Project name	This City, Rodney Street		
Design note title	Response to MCC Highways Comments		
Document reference	18321-HYD-XX-XX-TP-RP-1005		
Author	Christopher Peachey BA (Hons)		
Checker	Sam Denby BA (Hons) MSc CMILT		
Revision	2		
Date	2 August 2022	Approved	✓

1. INTRODUCTION

Figure 2.1 Rodney Street Visibility

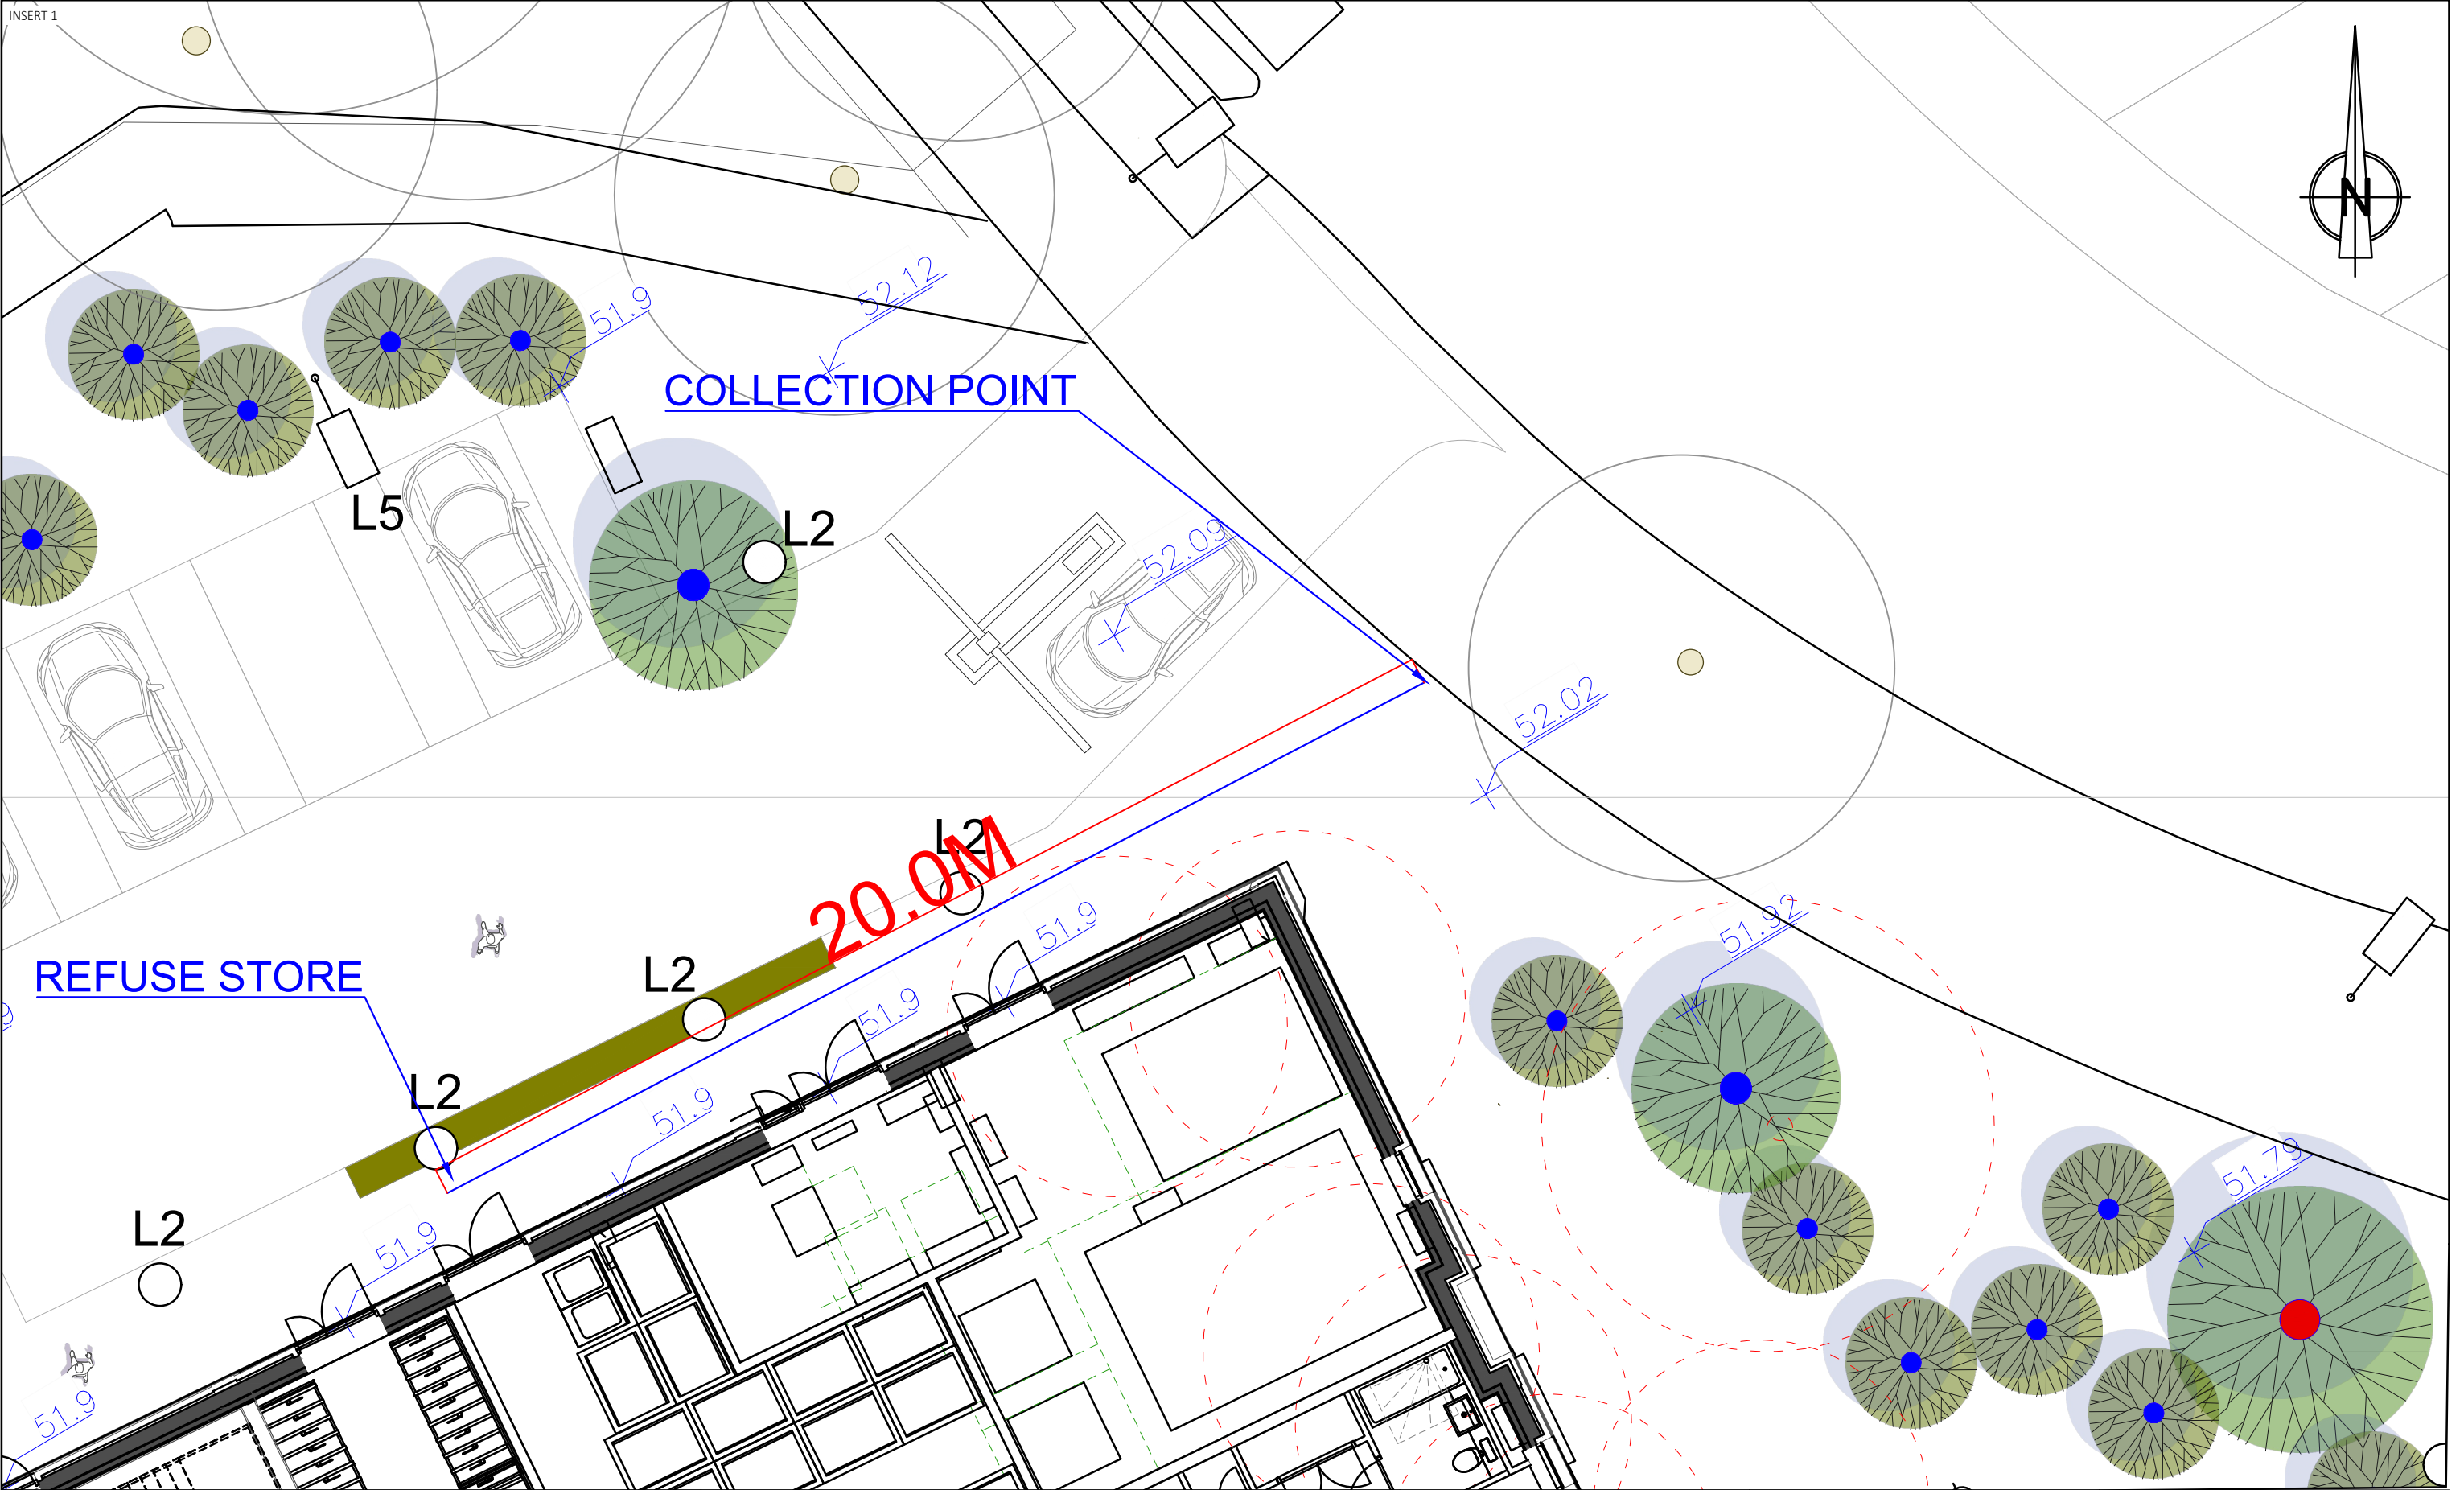
We asked that visibility splays and evidence that passing width drawings were submitted for comment. Drawing 18321-HYD-XX-XX-DR-TP-0004 does demonstrate that vehicles can pass a waste vehicle on Butler Street. However, Highways do have concerns with this arrangement. We would further request that visibility splays of a vehicle egressing from Rodney Street to Butler Street, with a parked refuse vehicle, is submitted.

- 2.5.1 At the request of MCC Highways, Hydrock have produced additional plans to demonstrate the visibility splay from the junction of Rodney Street and Butler Street.
- 2.5.2 The additional drawings are presented within **Appendix C**.
- 2.5.3 The left-hand visibility splay from Rodney Street to Butler Street does not demonstrate a highway safety concern as opposing traffic is on the opposite side of the road and is visible from the junction of Butler Street and Oldham Road approximately 110m away. This is presented in **Figure 2.1** below.

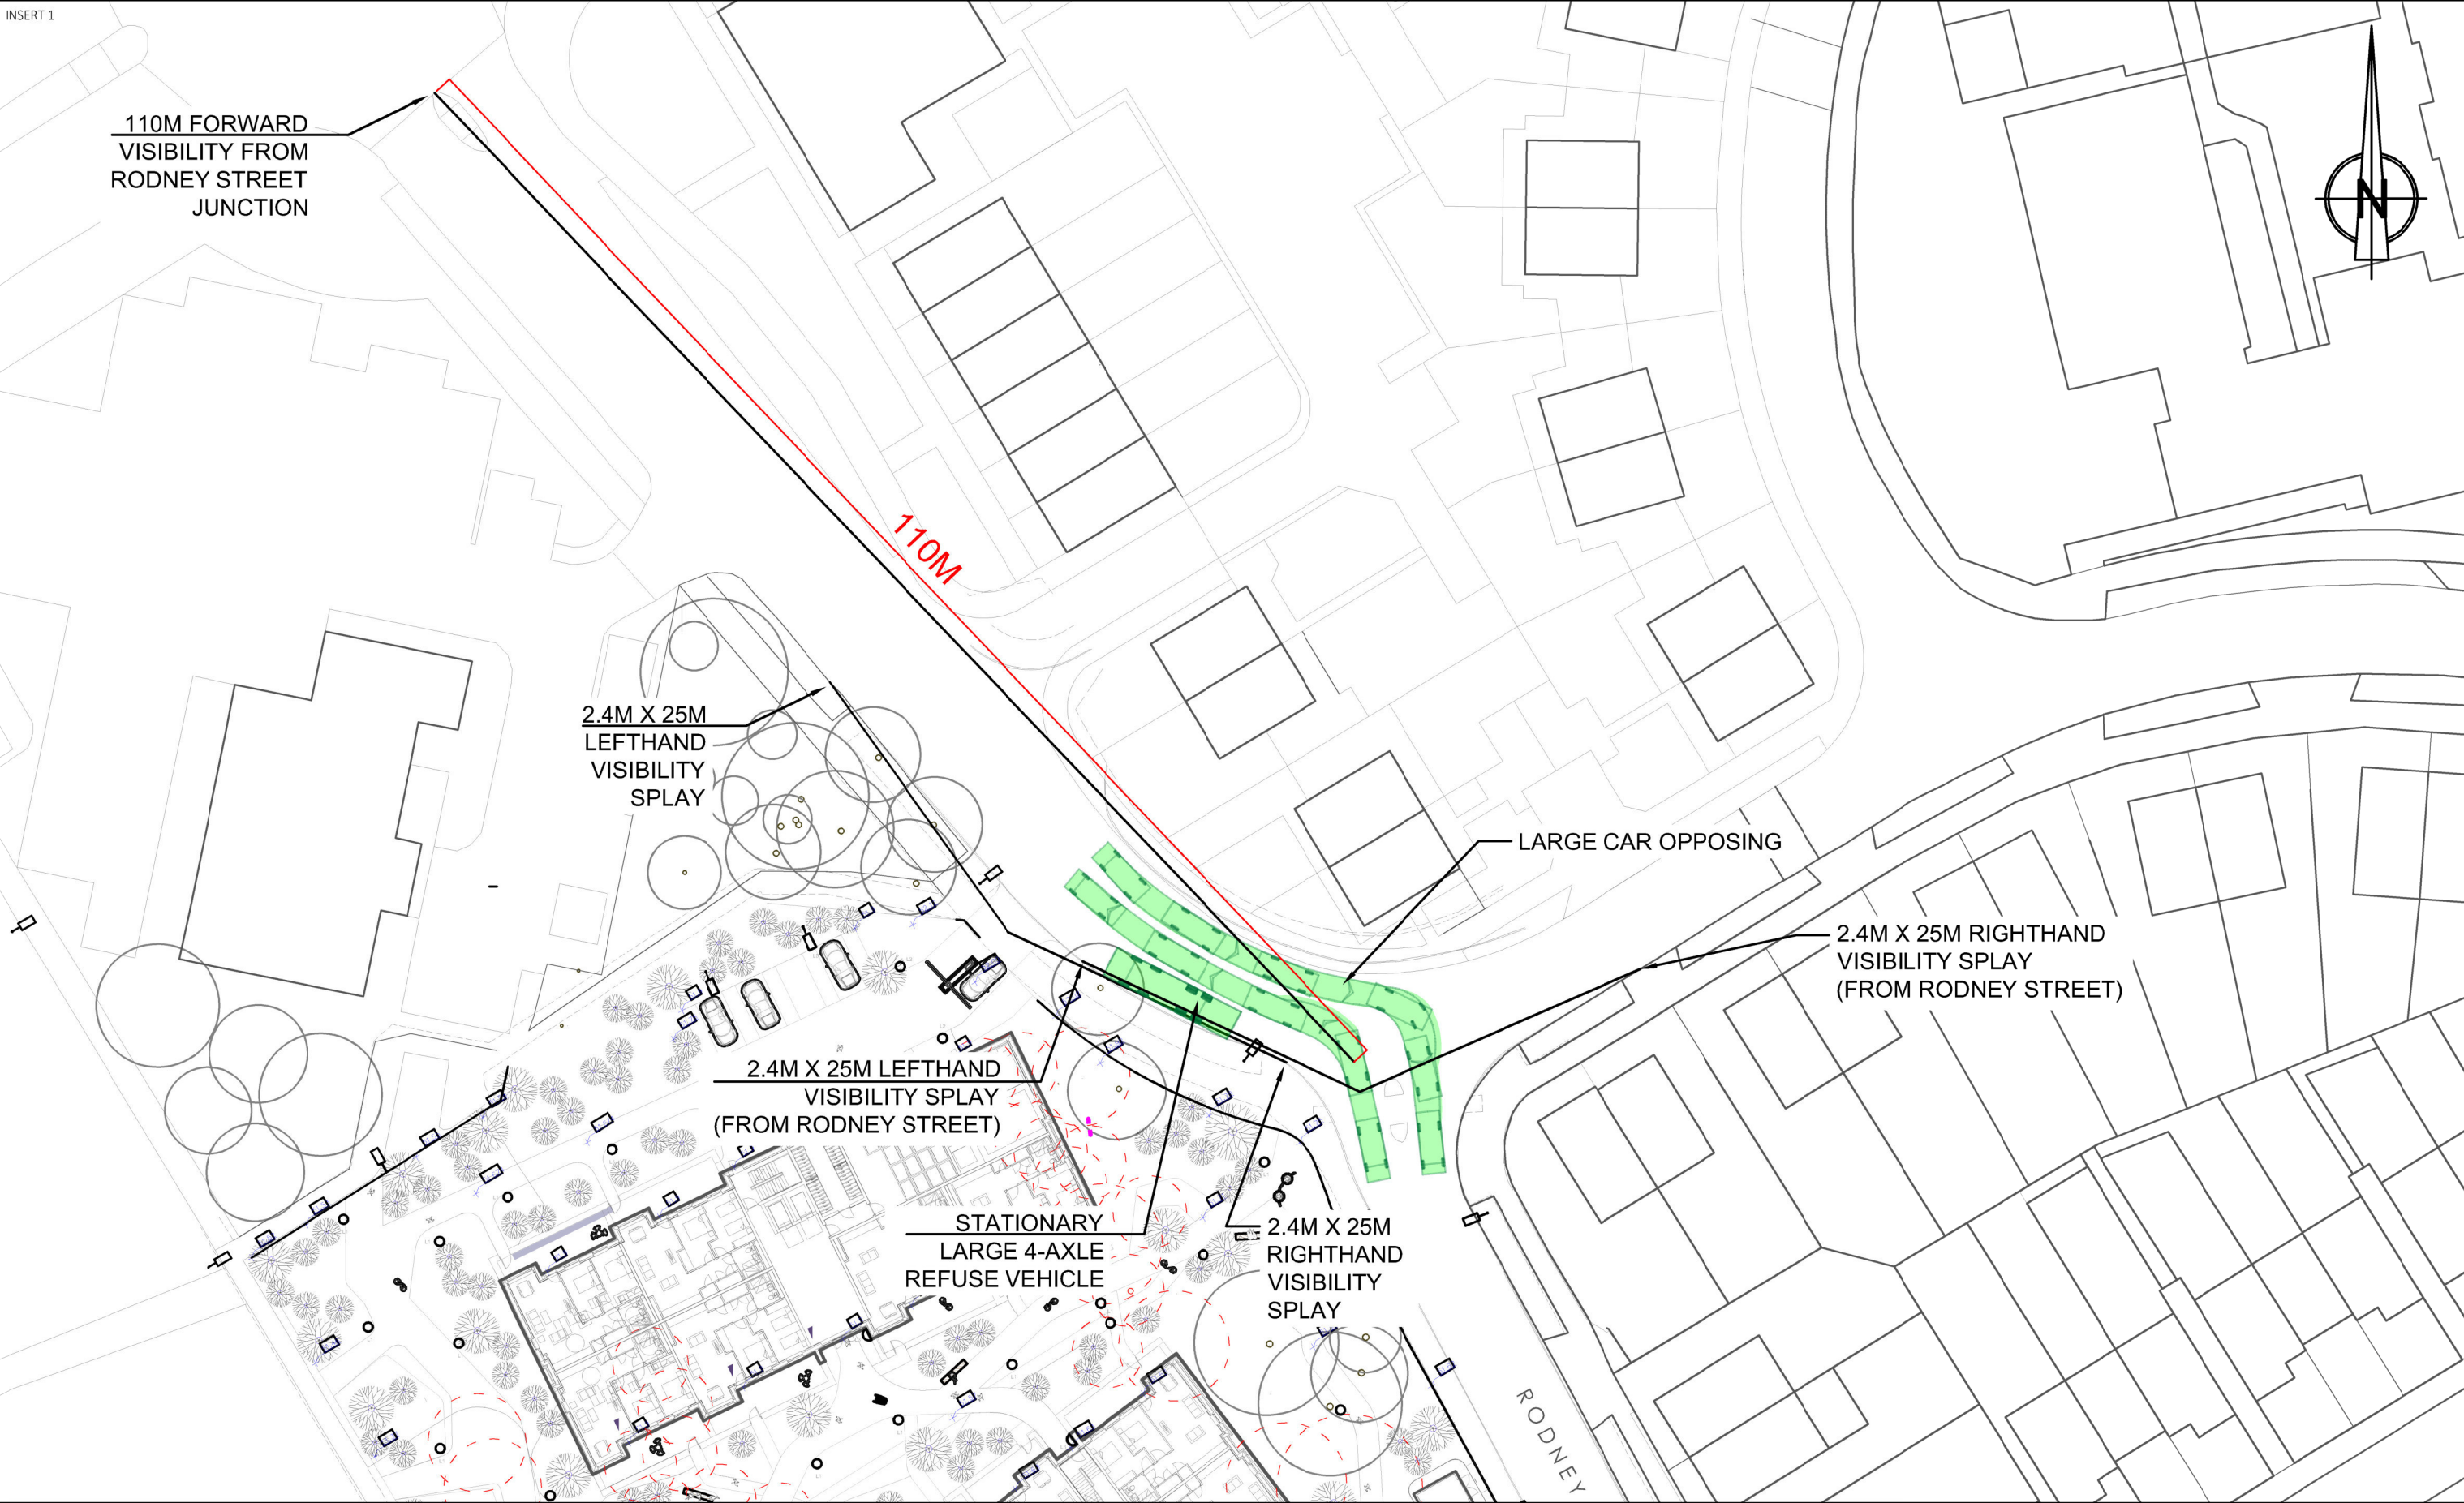
REFUSE AND SERVICING: Block A: Refuse collection for Block A will be undertaken from Butler Street on the north-eastern side. A refuse store is in place on the ground floor and bins will be taken to the collection point on collection day. Refuse will not be stored on the adopted highway and transferred back to the bin store after collection. It should be ensured that the distance between the bin store and the collection point are not greater than those detailed within MCCs GD04 Standards.

- 2.4.1 The distance between the refuse store and the collection point is 20m, this is presented in **Appendix B** for ease of reference. This is within MCC's GD04 guidance and Manual for Streets guidance.
